FROM STA. 28+88	TO STA. 29+37
PROJECT NAME MONTPELIER	
NO. M66-M6400 (7)	PLOTTED 05/04/87
SURVEYED BY KASTNER-MOREAU 06/85	
SHEET 123	OF 335 SHEETS

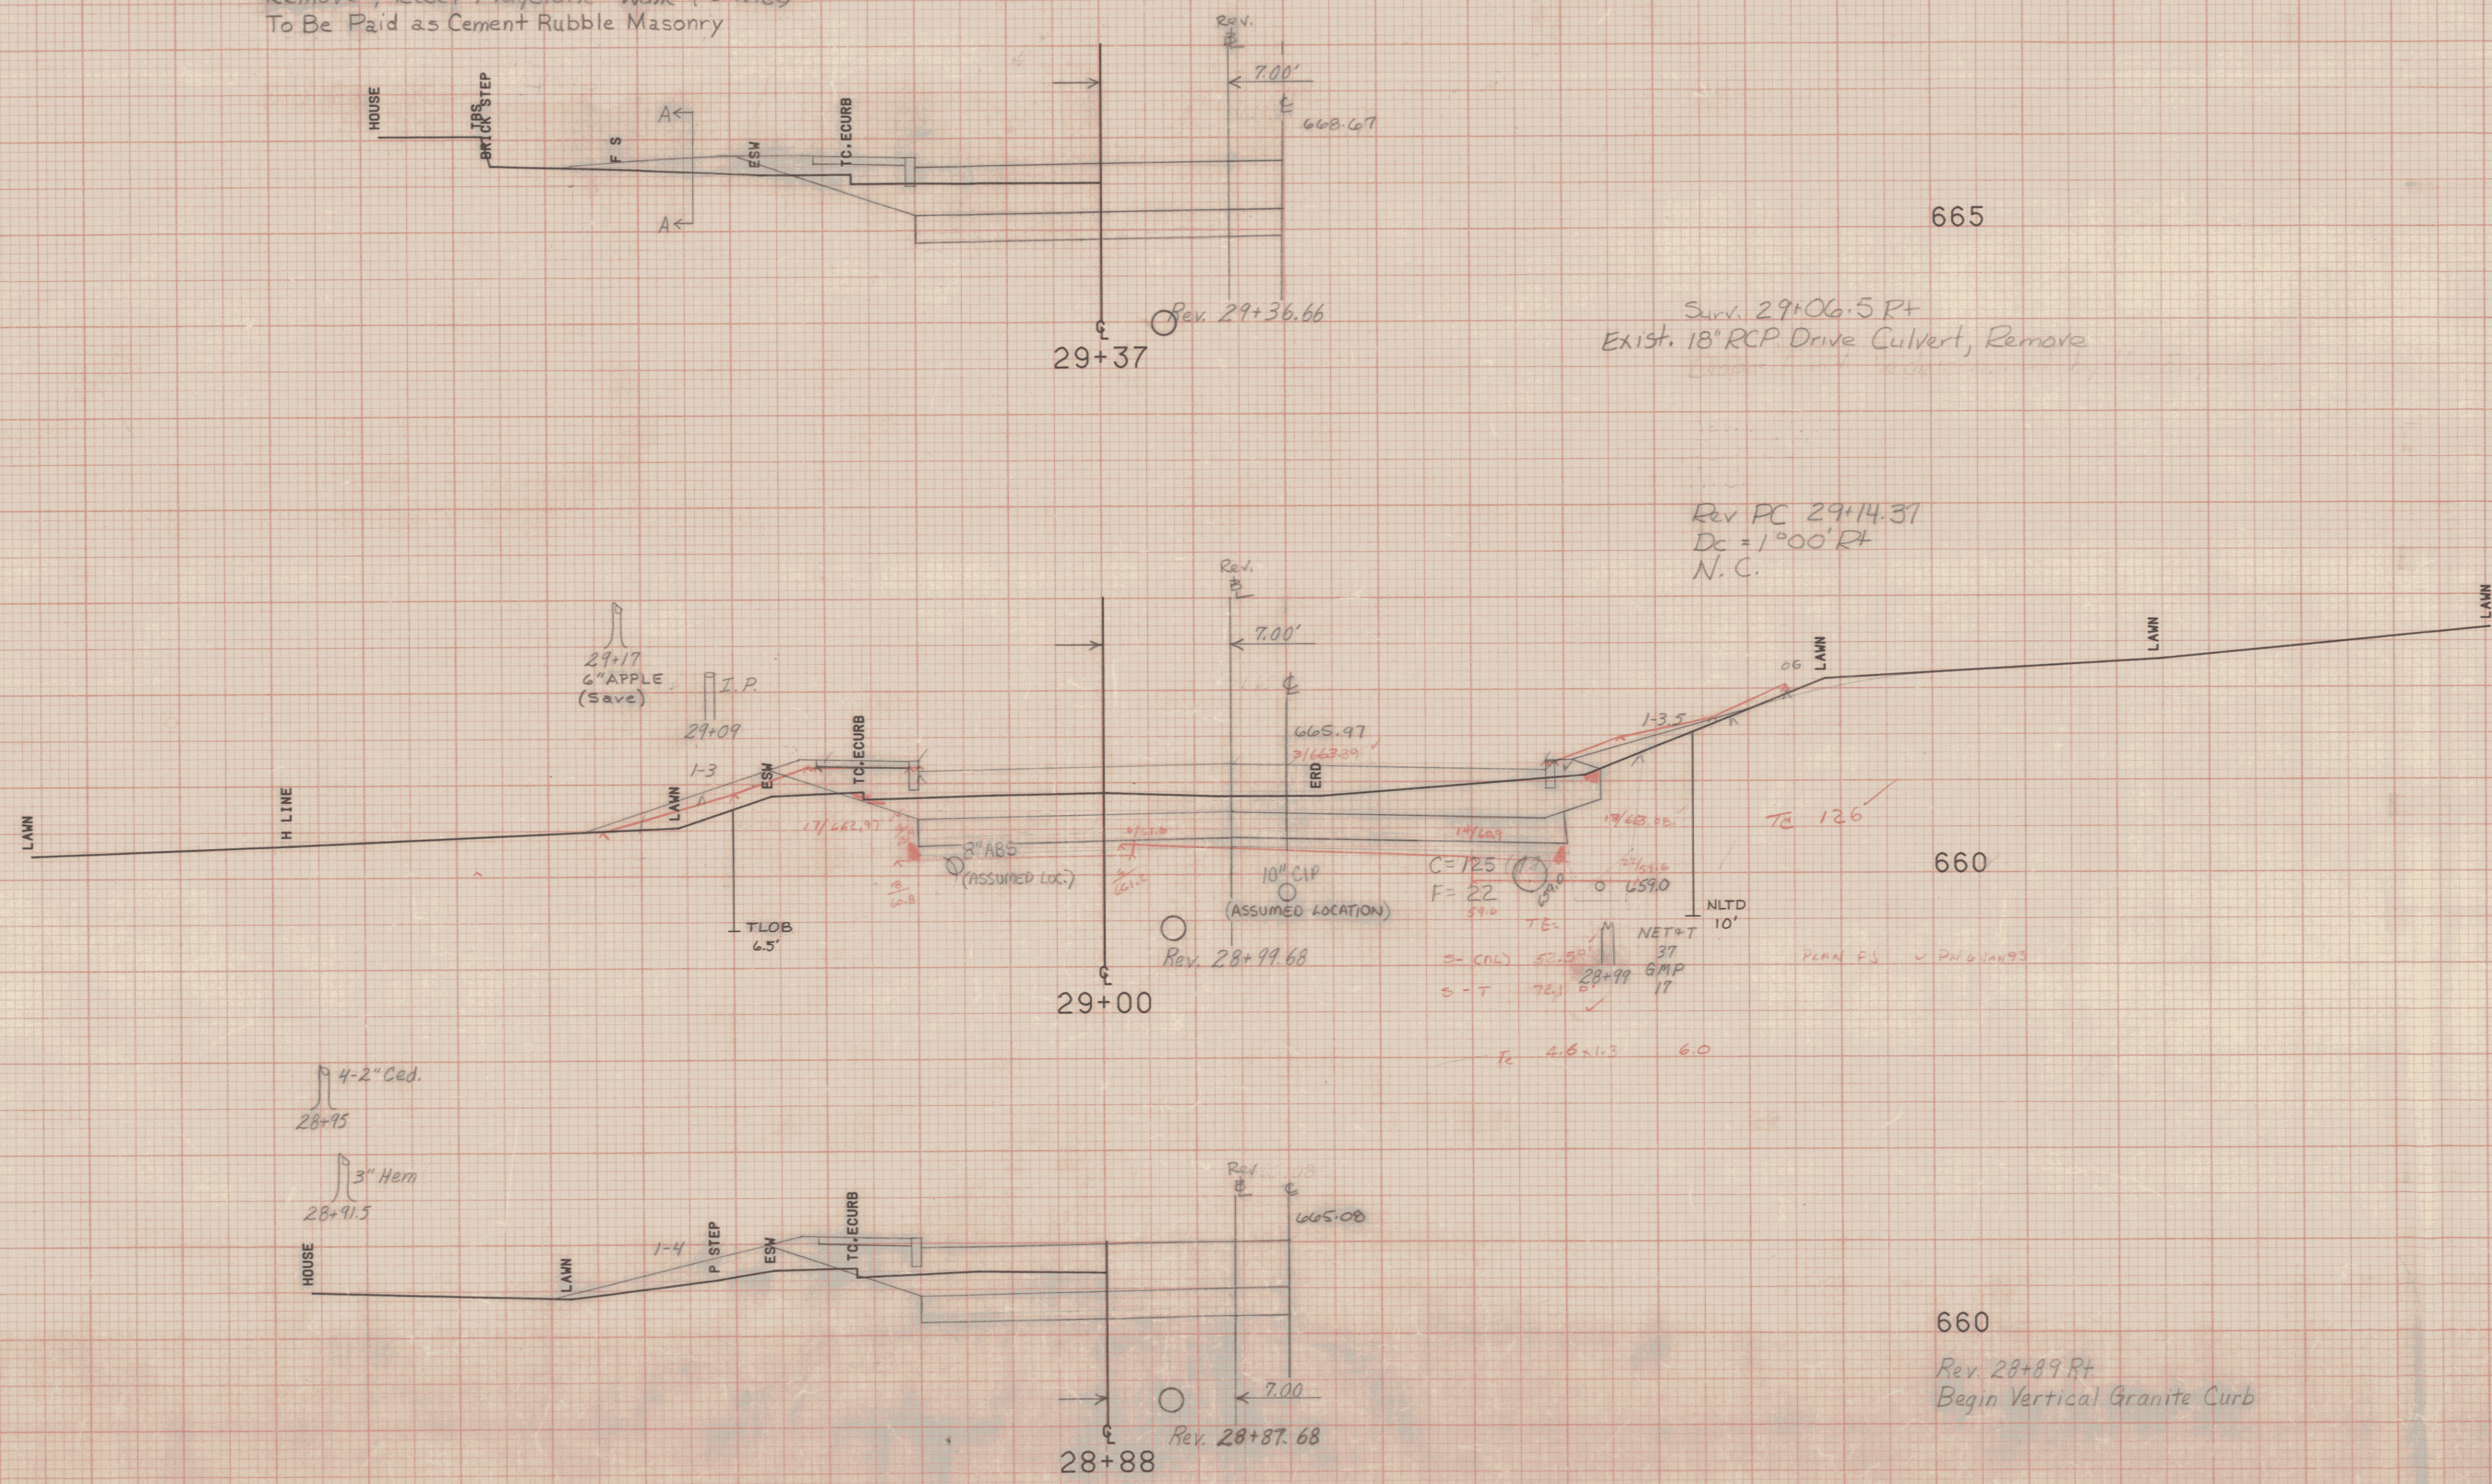
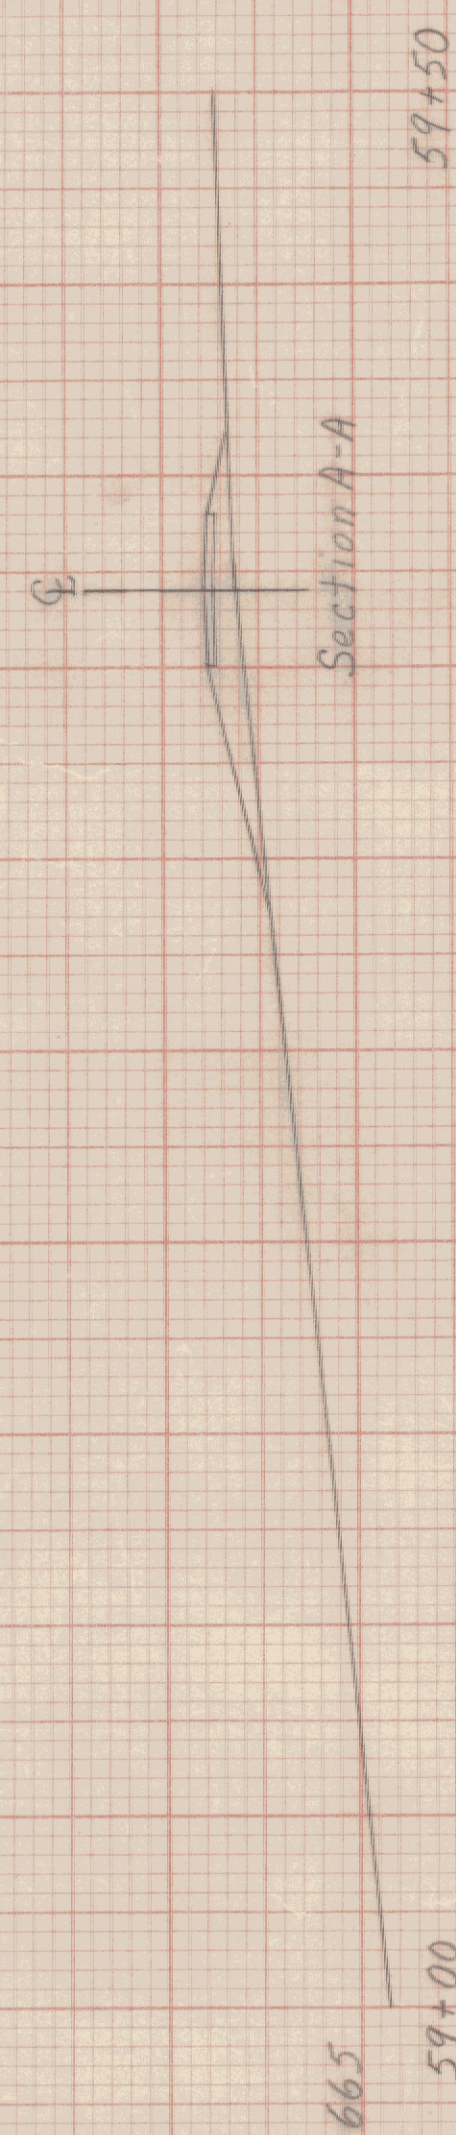
Rev. 29+44 RT
 Begin New 24" x 120" PCCSP .064 or CAAP .060
 End New 24" x 148" PCCSP .064 or CAAP .060

Rev. 29+48 LT
 End Vertical Granite Curb

Rev. 29+40 LT
 Remove & Reset Flagstone Walk (3' wide)
 To Be Paid as Cement Rubble Masonry

660
 Rev. 28+89 Rt
 Begin Vertical Granite Curb
